**Subject: Bid Package #2**  
Abbott Middle School HVAC Replcmt-DSA 01-119556  
George Hall Elementary School HVAC Replcmt-DSA 01 119523  
Laurel Elementary School HVAC Replcmt DSA 01-119551  
**San Mateo - Foster City School District**

**ADDENDUM NO. 1**

**Subject:** Abbott Middle School HVAC Replacement  
San Mateo - Foster City School District  
Aedis Project No. 2021005.06  
DSA Application #01-119556

### ADDENDUM NO. 1

DATE 11/24/2021  
JOB # 2021005.02  
SHEET # AD1-  
**A2.01**

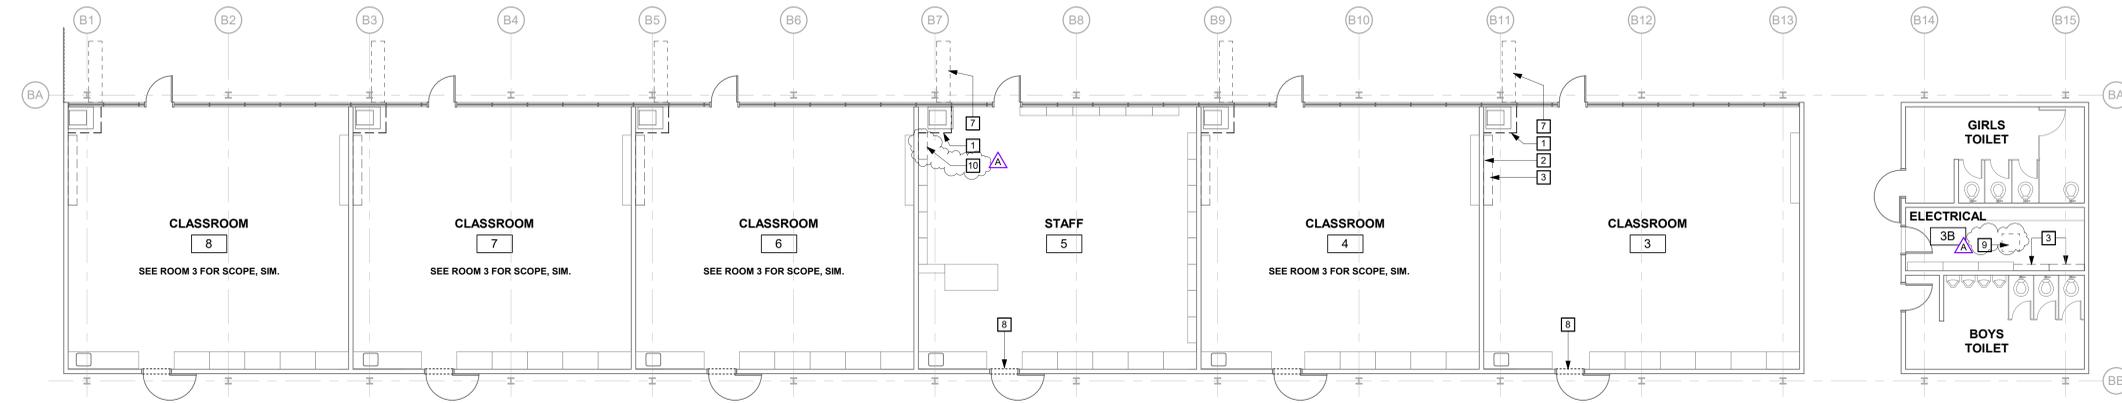
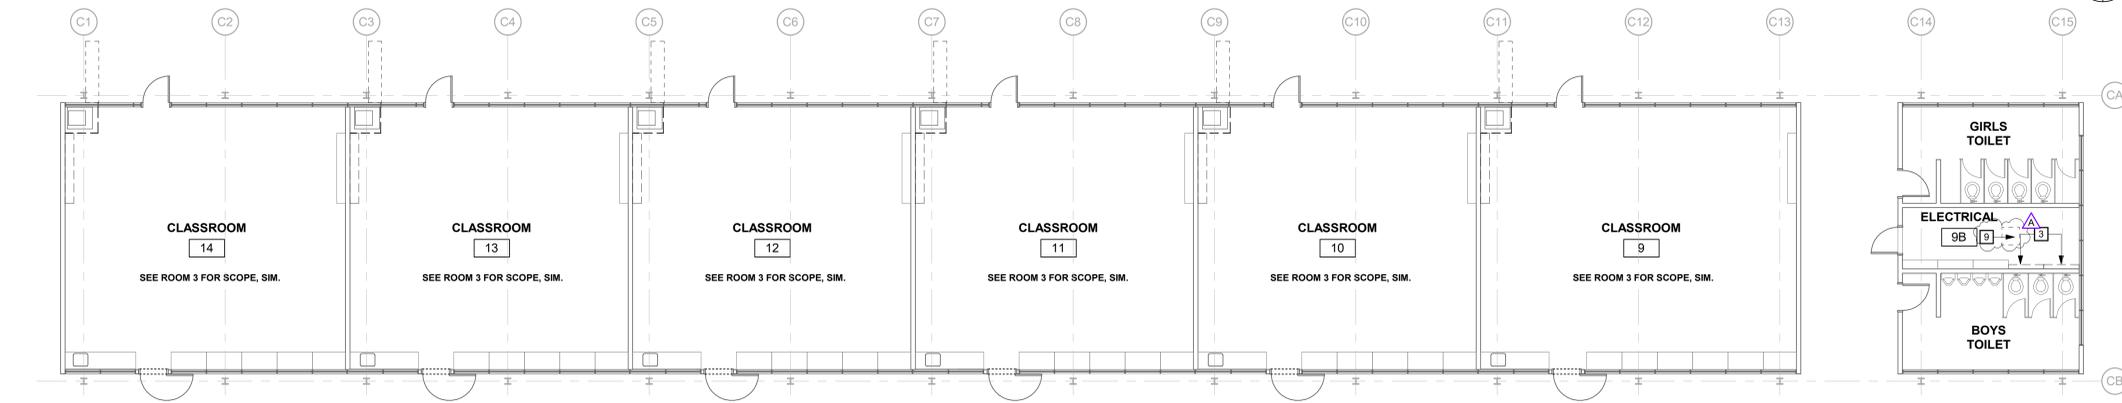
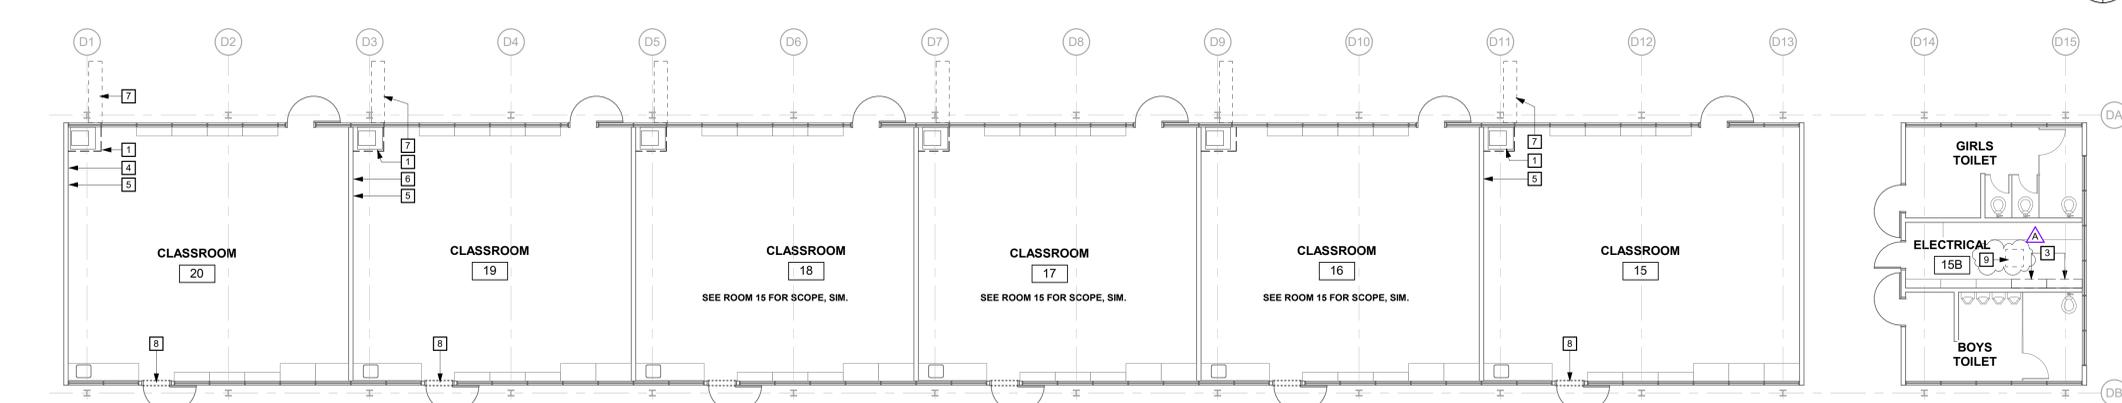
ITEM NO. 1.6: DRAWING SHEET A2.01 – DEMOLITION FLOOR PLANS – WINGS 1, 2, 3, 4

- Add: General Sheet Note #J per AD1-A2.01
- Add: Demolition Floor plan Keynotes #9 & #10 per AD1-A2.01
- Add: Partial ceiling demolition keynote #9 at Demolition Floor Plans 2/A2.01, 3/A2.01, and 4/A2.01 per AD1-A2.01
- Revise: At Classroom 5 replace keynote 2 with keynote 10 per AD1-A2.01

DATE 10/04/2021  
JOB # 2021005.02  
SHEET # AD1-  
**A2.02**

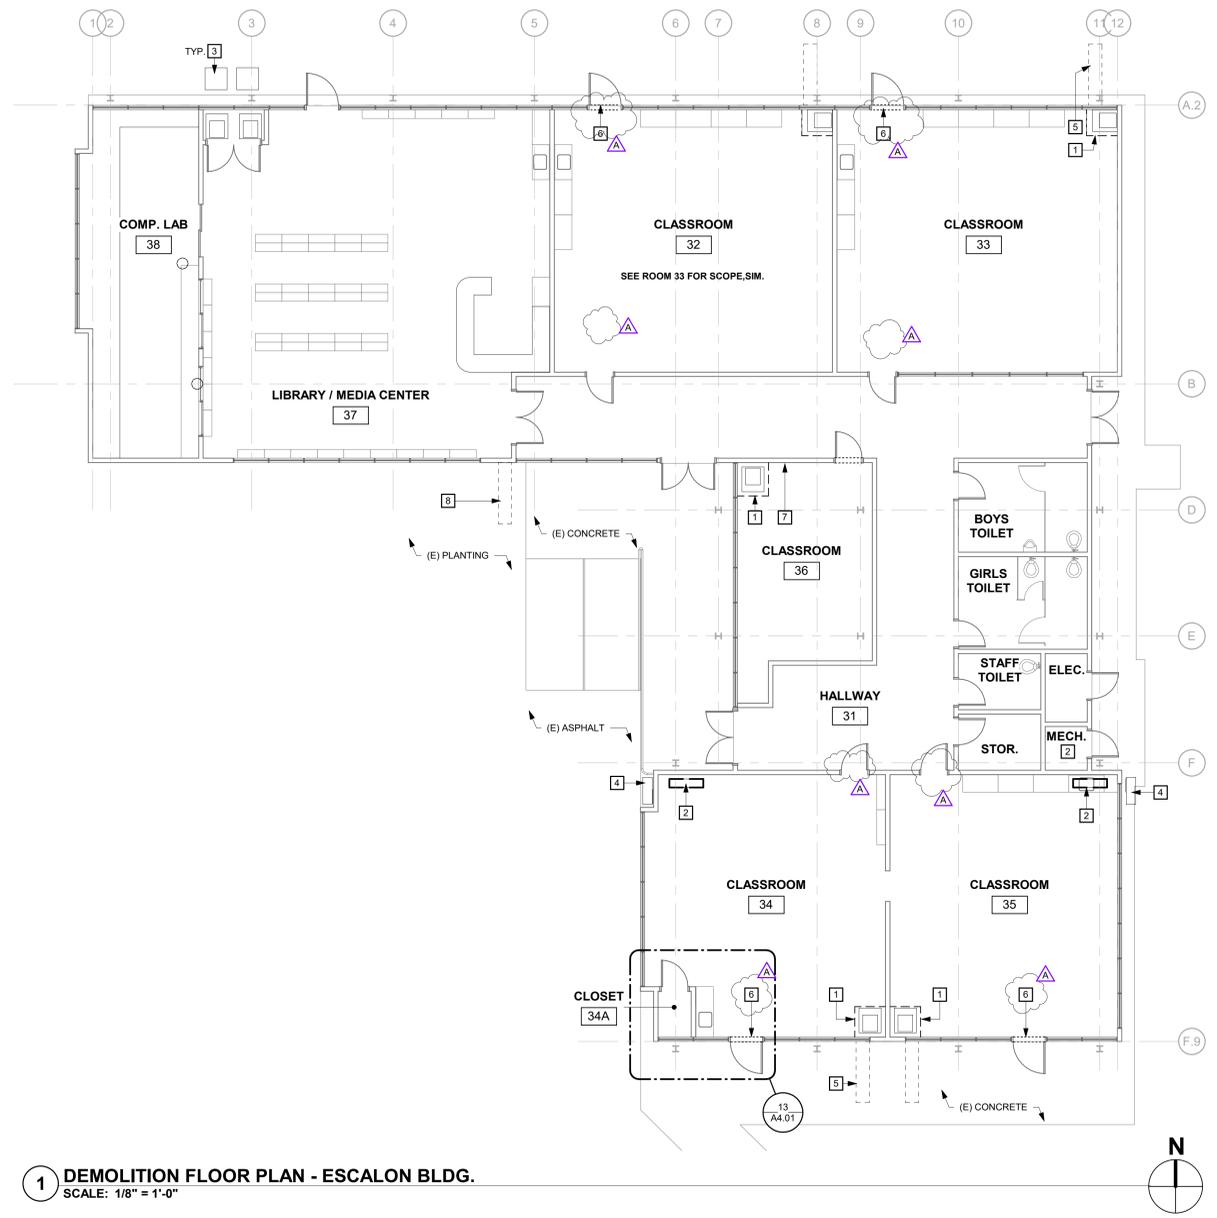
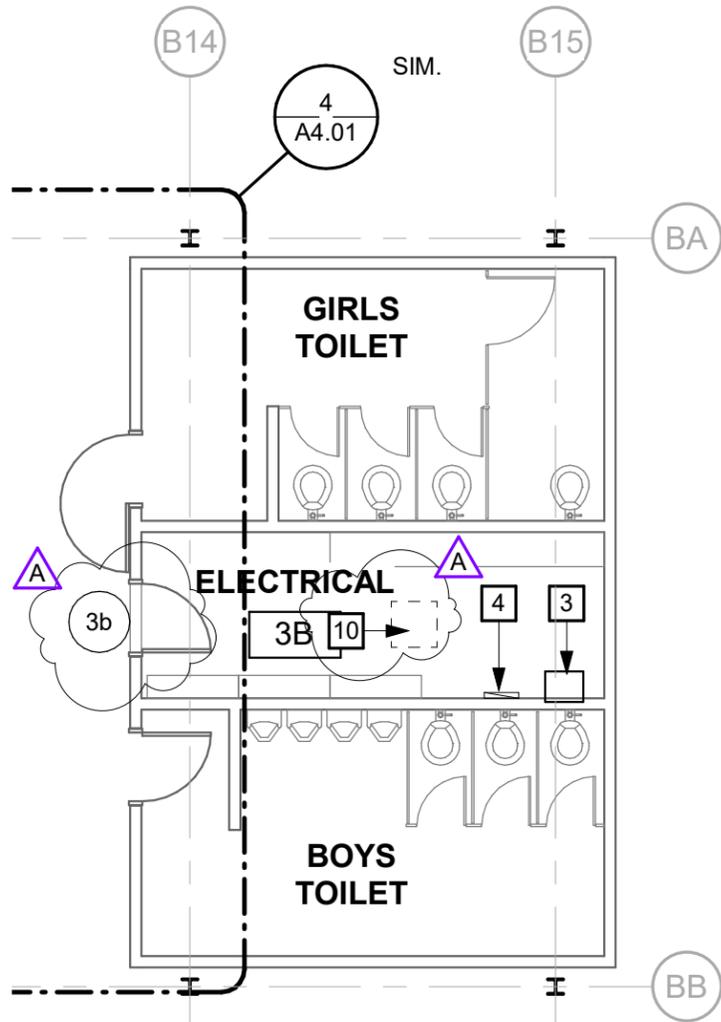
ITEM NO. 1.7: DRAWING SHEET A2.02 – DEMOLITION FLOOR PLAN - ESCALON BLDG

- Revise: Floor Plan Keynote #6 locations per AD1-A2.02
- Add: General Sheet Note #J per AD1-A2.02

**2 NEW FLOOR PLAN - WING 2**  
SCALE: 1/8" = 1'-0"

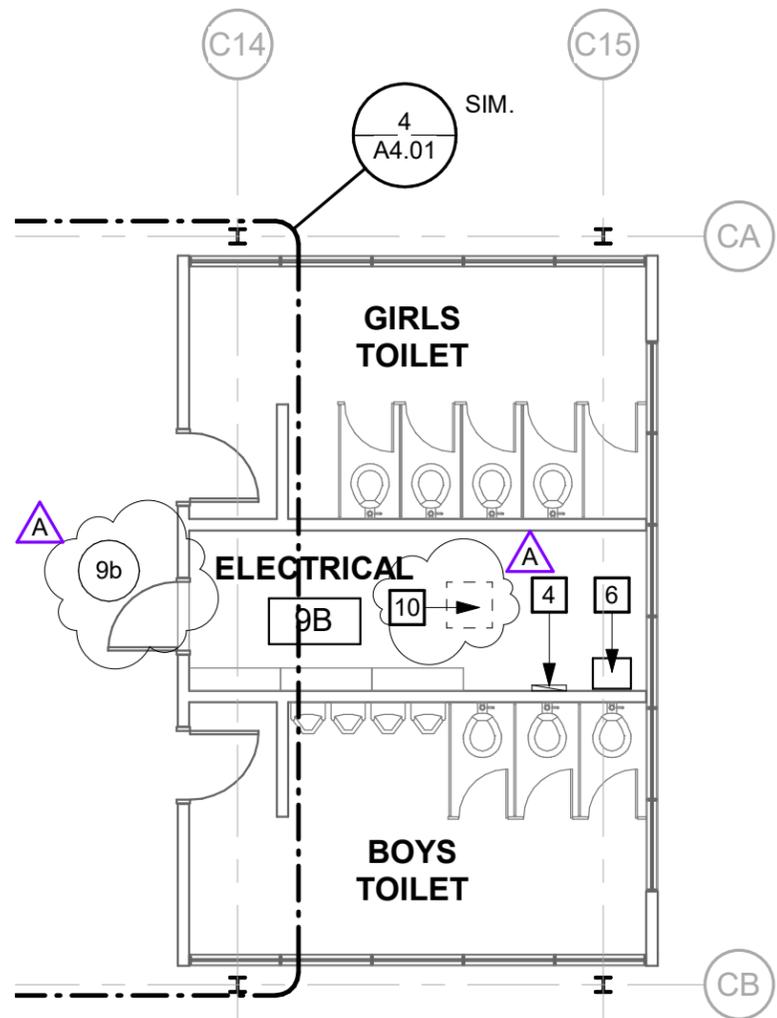
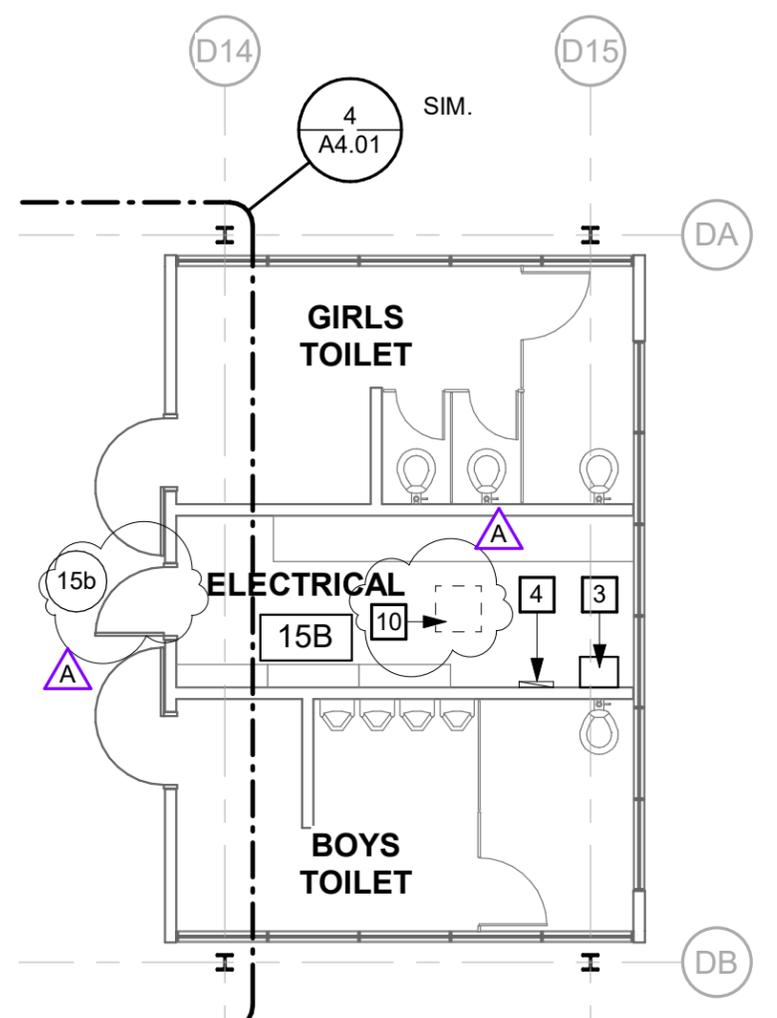
ITEM NO. 1.8: DRAWING SHEET A3.01 – NEW FLOOR PLANS – WINGS 1, 2, 3 & 4

- Add: Door tags 3b, 9b & 15b to New Floor Plans 2/A3.01, 3/A3.01, and 4/A3.01 per AD1-A3.01
- Add: Ceiling patching keynote #10 to New Floor Plans 1/A3.01, 2/A3.01, and 3/A3.01 per AD1-A3.01
- Revise: New Floor Plan Keynotes #8 & #9 per AD1-A3.01

- 7 PATCH PAVING AT DRY WELL. SEE 6/A8.10 AND S.M.D.
- 8 PATCH AND PAINT EXTERIOR FACE WHERE FIRST SECTION OF CASEWORK HAS BEEN REMOVED.
- 9 REFER TO 5/A4.01 FOR TYPICAL CLASSROOM NEW REFLECTED CEILING PLAN. REMOVE AND REINSTALL (E) ACOUSTICAL CEILING TILES ABOVE AS REQUIRED FOR CONSTRUCTION ACCESS INCLUDING BUT NOT LIMITED TO ELECTRICAL ROUTING, MECHANICAL DUCTWORK ANCHORAGE, BLOCKING FOR ROOFTOP PLATFORMS. DO NOT ALTER SUSPENDED A.C.T. GRID.
- 10 PATCH AND PAINT GYP. BD. CEILING ADJACENT EXHAUST FAN, S.M.D.

1 PARTIAL SITE ROOF PLAN  
SCALE: 1/16" = 1'-0"

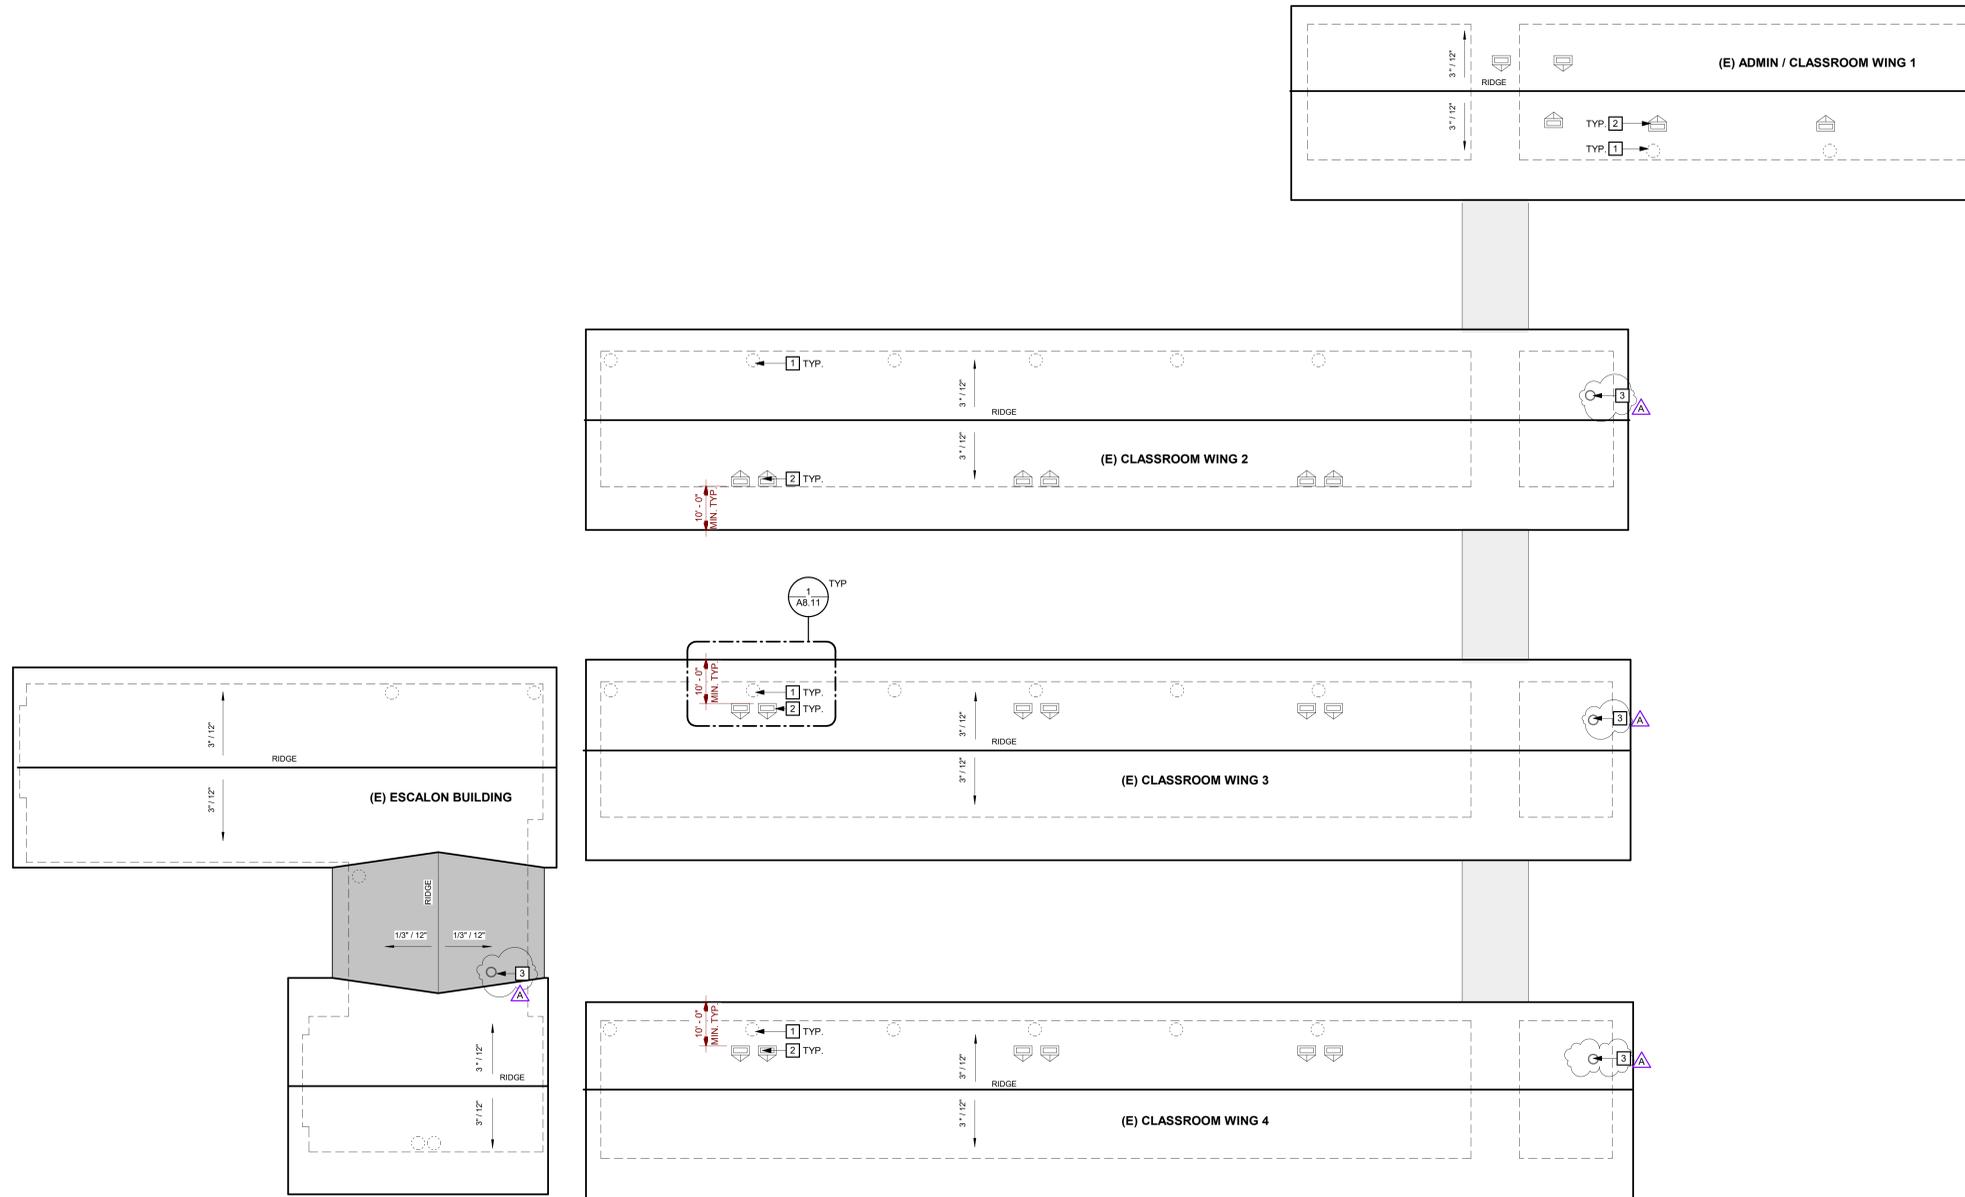
ITEM NO. 1.9: DRAWING SHEET A5.01 – PARTIAL SITE ROOF PLAN

- Add: Exhaust fans per AD1-A5.01
- Add: Partial Site Roof Plan Keynotes #3 per AD1-A5.01
- Revise: Partial Site Roof Plan Keynotes #2 per AD1-A5.01

- 1 PATCH (E) PENETRATION AT REMOVED FLUE AND COMBUSTION AIR INTAKE AND PATCH (N) PENETRATIONS. S.M.D. AND SEE DETAIL 17/A8.10
- 2 MECHANICAL UNIT ON PLATFORM WITH CRICKET. S.M.D. AND SEE DETAIL 19/A8.10. REMOVE (E) ROOFING TO SUBSTRATE FOR CONSTRUCTION ACCESS.
- 3 EXHAUST FAN SEE 10/A8.10 SIM. S.M.D. REMOVE (E) ROOFING TO SUBSTRATE AND PREP OPENING AS REQUIRED FOR NEW WORK.
